Road & Bridge Design Publications

Monthly Update – July 2012

Special Details

END WALL ELEVATION

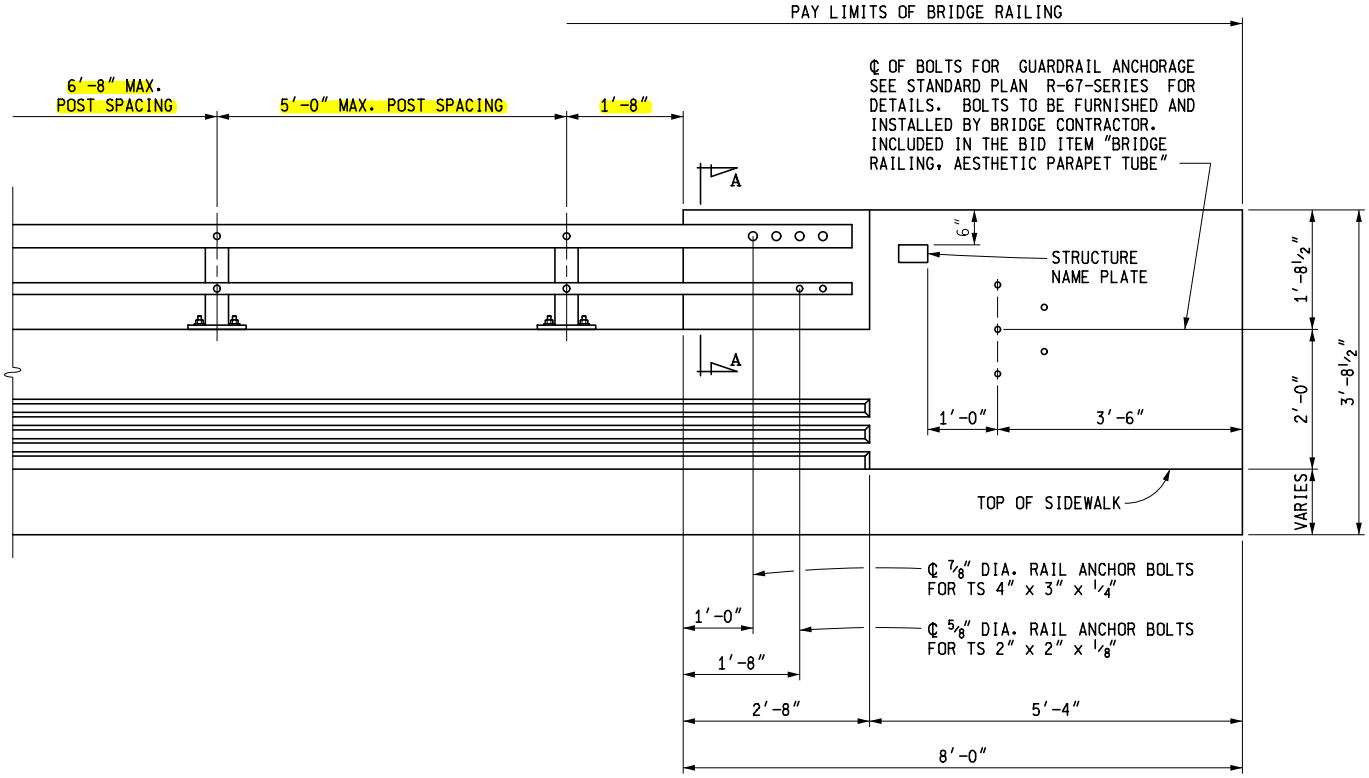
B-25-G: Bridge Railing, Aesthetic Parapet Tube**:** The end wall elevation sketch on sheet three was revised to show closer post spacing at the end wall.
